AMENDMENT TO THE COASTAL MARSHLANDS PROTECTION PERMIT APPLICATION DEAN CREEK NATURE TRAIL IMPROVEMENTS SAPELO ISLAND, GEORGIA

NOVEMBER 14, 2023

This amendment includes an updated section on Site Plans and Related Information, an updated topographic survey with updates to the JD Line, and updated permit drawings with the updated JD line.

PERMIT DRAWINGS

Sheet Title: SITE PLAN

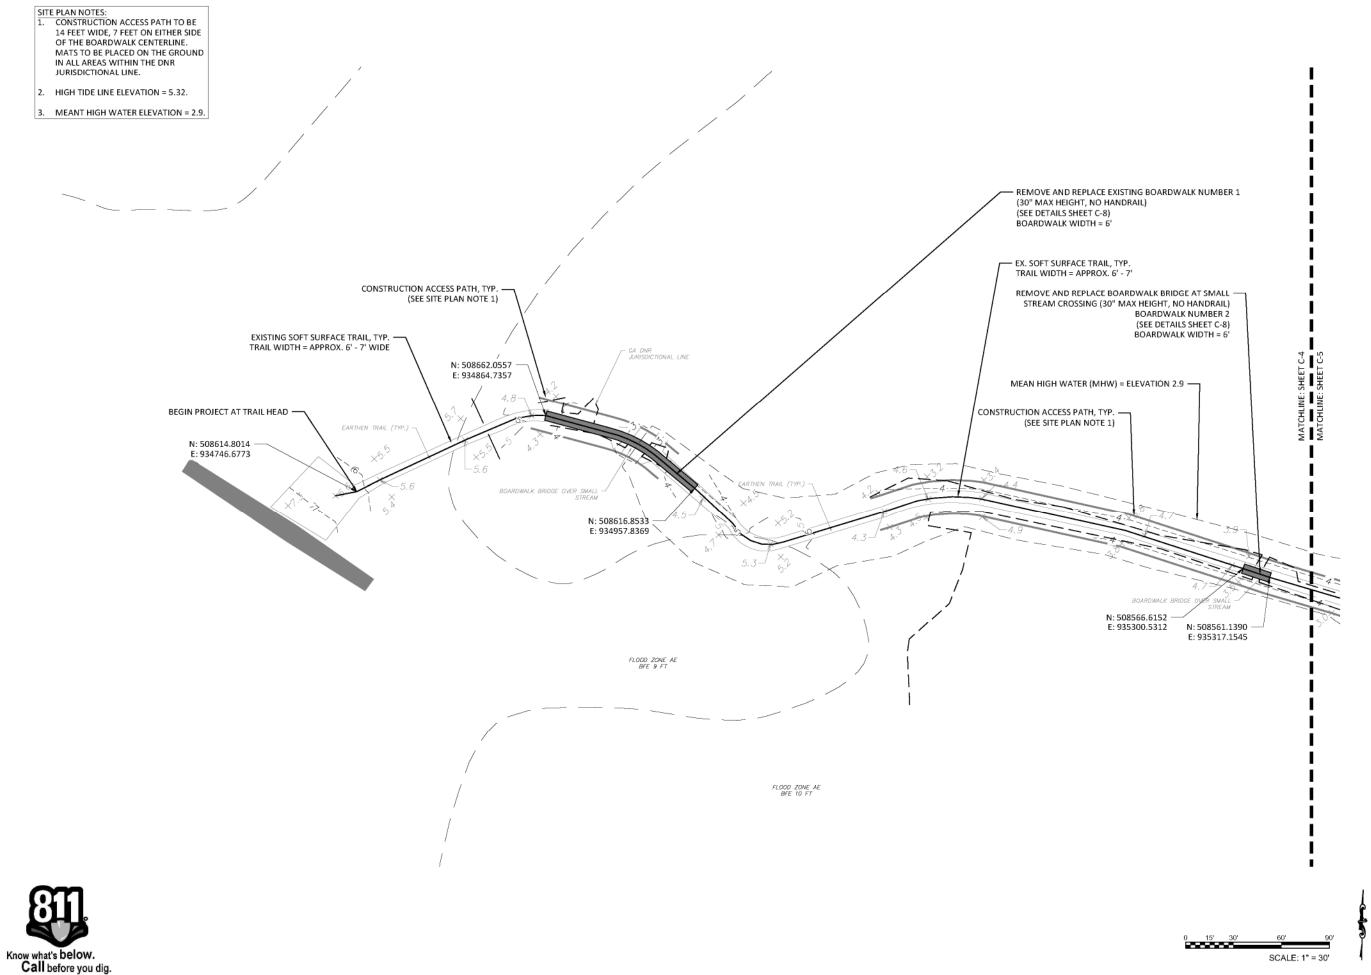
- Survey: Please have the JD lines reflect the 2 tidal stream crossings at boardwalk 1 and 2. There also needs to be a connection on the eastern side of the upland just before the berm is within jurisdiction. My sketch is attached.
- Marshlands Component: Add portions of boardwalk 1 and 2 that are crossing the tidal streams into the total impacts
 - Approximate sq.ft. of relocated soft trail within jurisdiction just to the west of boardwalk 4
 - After the berm is removed, will there be any supplemental plantings in its footprint or is the plan to just let nature take over?
- Upland component: add 50ft. buffer to all 4 boardwalks starting at the marsh/upland line, please include total sq.ft. of buffer at each location and any permanent and temporary impacts within those buffers.
 - Area of boardwalk 3 that is in the upland vs. in jurisdiction.

Revisio	ns:	
NO.	DATE	DESCRIPTION
1	11/20/2023	UPDATED TOPO
	_	
	_	
	1
